Service Bulletin: SB A119-306; Agusta A119 Air Conditioner Compressor Drive Belt Change from "Cogged" to Poly-V Belt.

Subject: Removal & Replacement of A119 Air Conditioner Compressor Drive Belt Design Change.

Date: 26 August 2005, Rev D (previous revisions never issued).

Applicability: Agusta A119 Helicopter, Equipped with the Air Comm Corporation A119-204-1 & -2 Air Conditioning Systems.

Figure 1.1
Electrical Installation

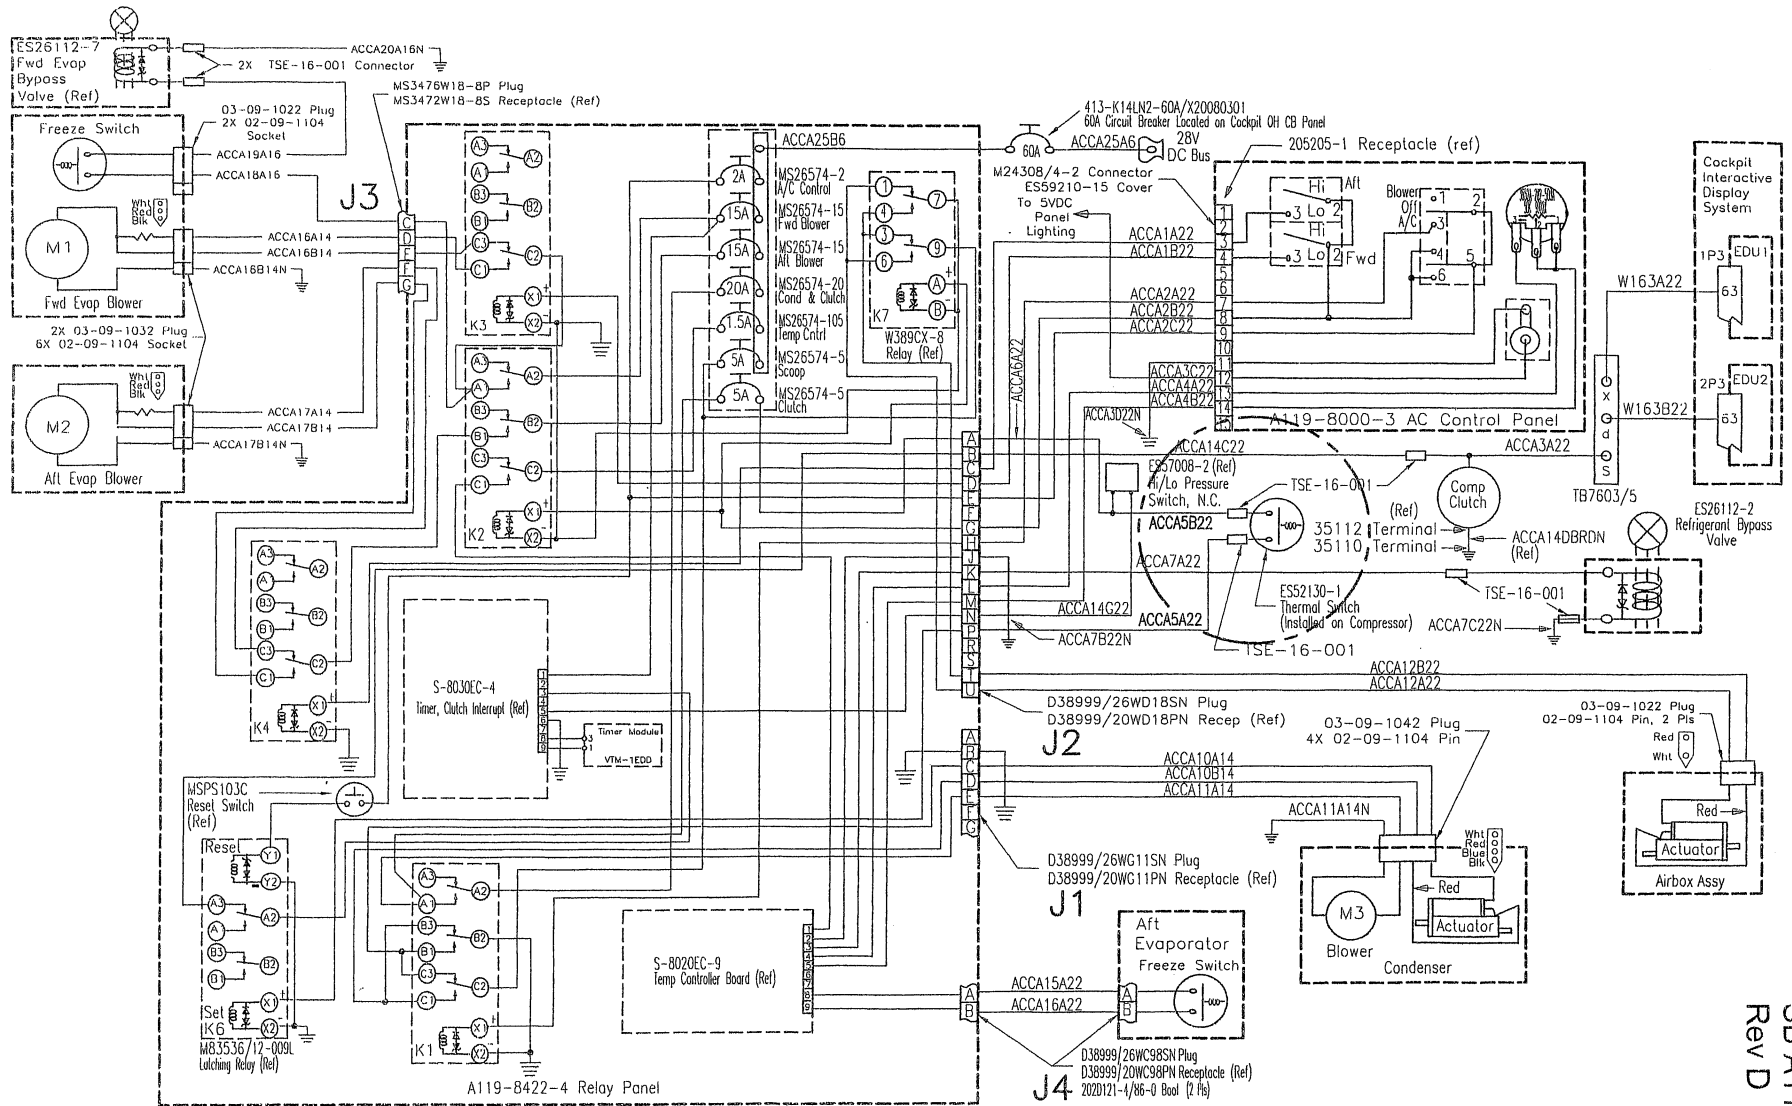
2. Disconnect #8 and #10 refrigerant lines from the ports located on the aft side of the air conditioner compressor body. Remove and discard O-rings from hose fittings. Cap lines to prevent contamination, and oil loss from the system.
3. Cut safety wire, and loosen Jam nuts on compressor belt tensioning link assembly. Turn the barrel section of the link assembly to loosen the compressor belt tension.
4. Disconnect the Compressor clutch wire at the compressor.
5. Disconnect and Cap wires ACCA5A22 & ACCA5B22 connecting to the compressor temperature sensor wires using two each 35115 caps, and secure wires as necessary. (Figure 1.1)

The new A119-3040-1 Compressor assembly is not equipped with a temperature sensor, therefore the need to cap and secure wires ACCA5A22 & ACCA5B22 is required to comply with this Service Bulletin.

Figure 1.2
Drive Pulley Installation

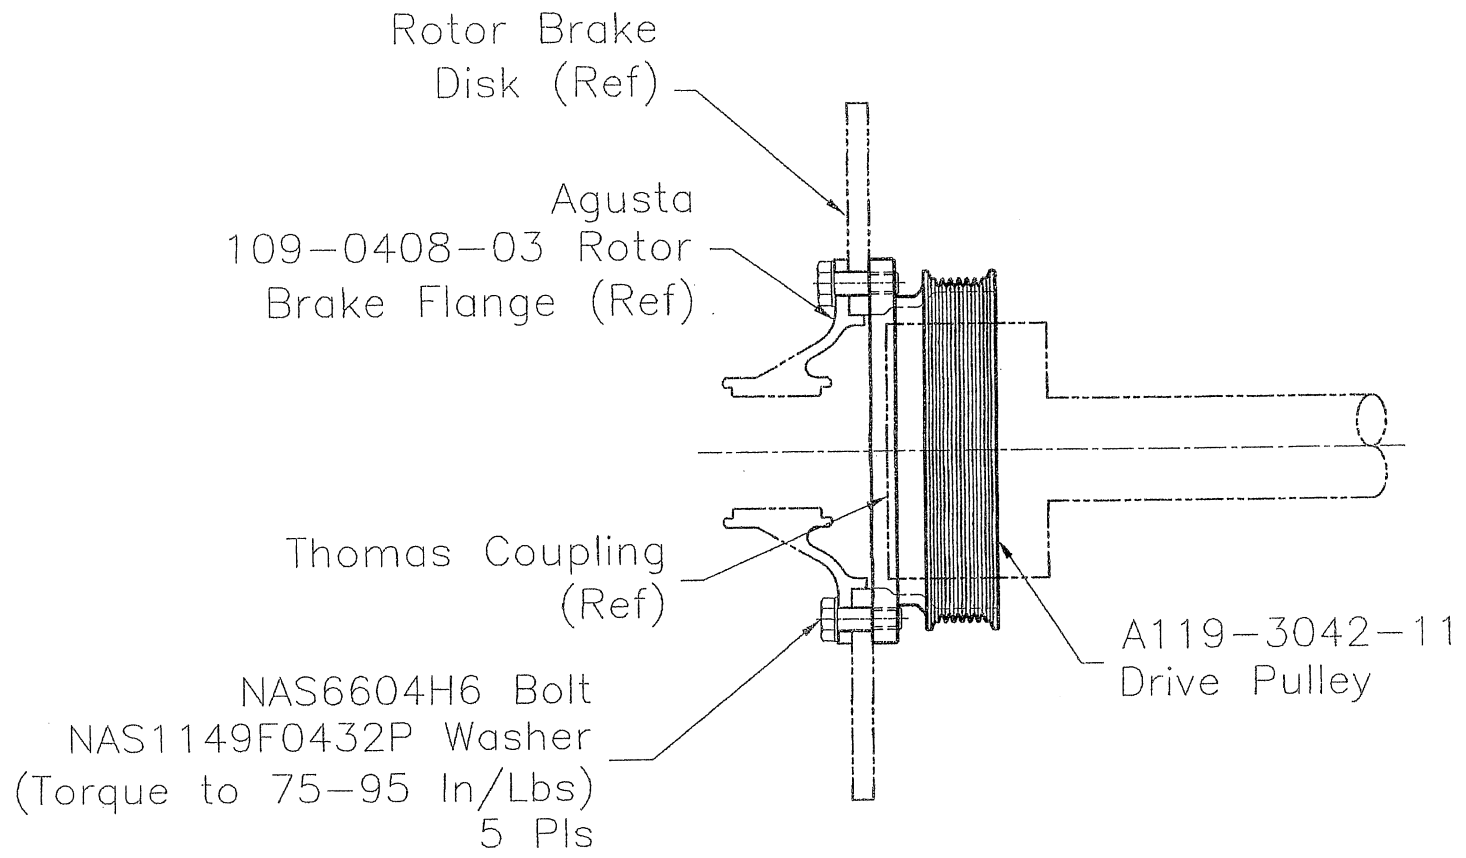
1. Install new A119-3042-11 Drive Pulley, NAS6604H6 Bolts, and ES35119-2 Belt on the oil cooler driveshaft / rotor break disc assembly. Torque bolts 75 to 95 in-lbs. Safety wire using .032 safety wire. (Figure 1.2)

Figure 1.3
Compressor Installation

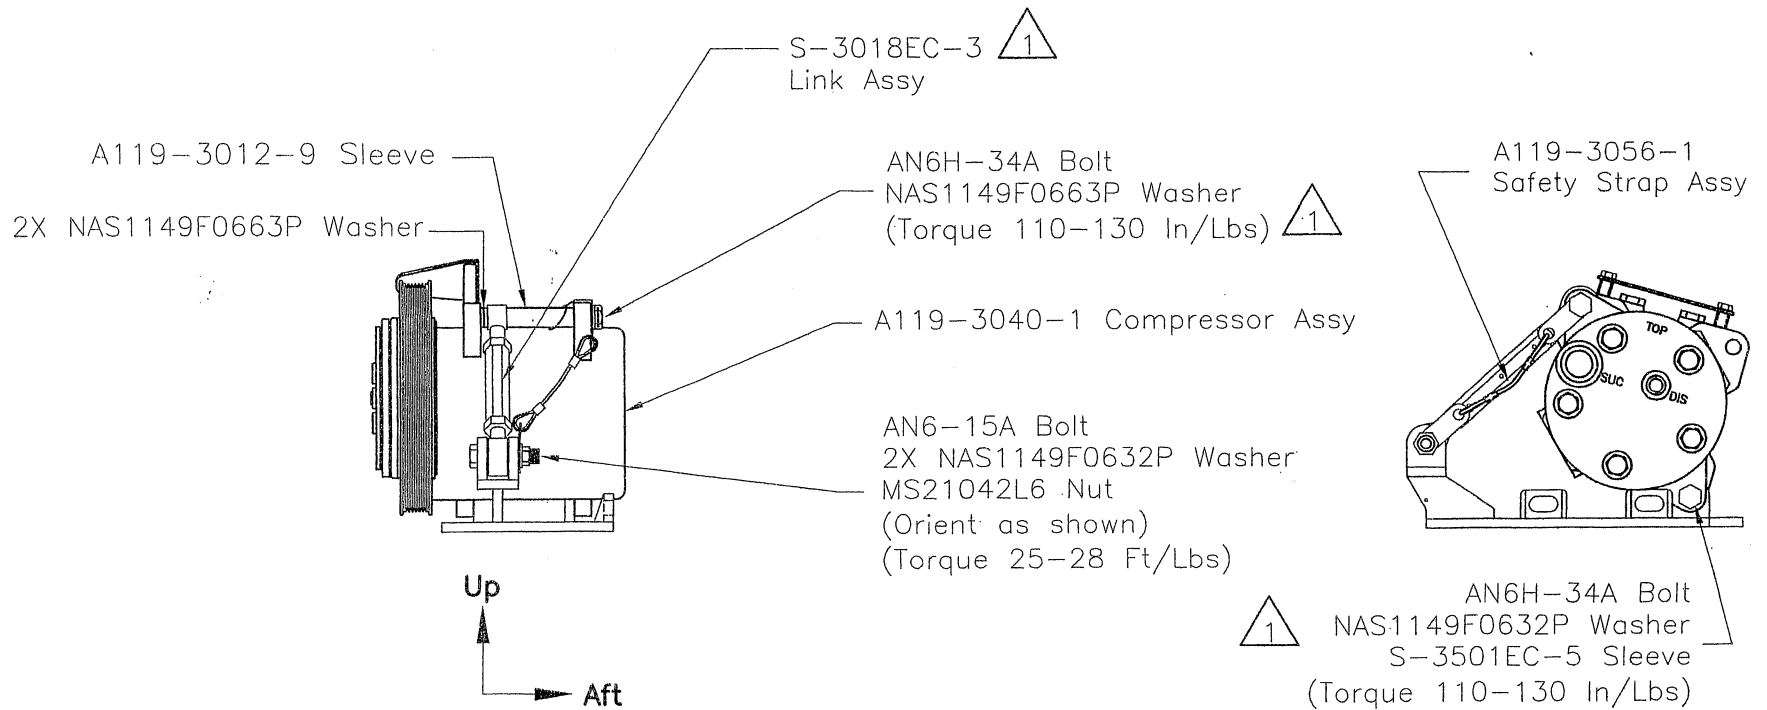
2. Install new A119-3040-1 Compressor on existing compressor mount assembly, reinstall AN6H-34A Bolt, A119-3056-1 Safety Strap NAS1149F0633P Washers in upper and lower compressor mounting lugs. Reinstall the A119-3012-9 sleeve, and install new S-3018EC-3 belt tensioning link on the upper and lower mounting bolts and torque 110 to 130 in-lbs. (figure 1.3)

The A119-3056-1 Safety Strap **MUST** be installed exactly as shown in figure 1.3

Safety wire as shown per Mil-P-8564 Para 3.3.7 using MS20995C-32 Safety Wire at final installation
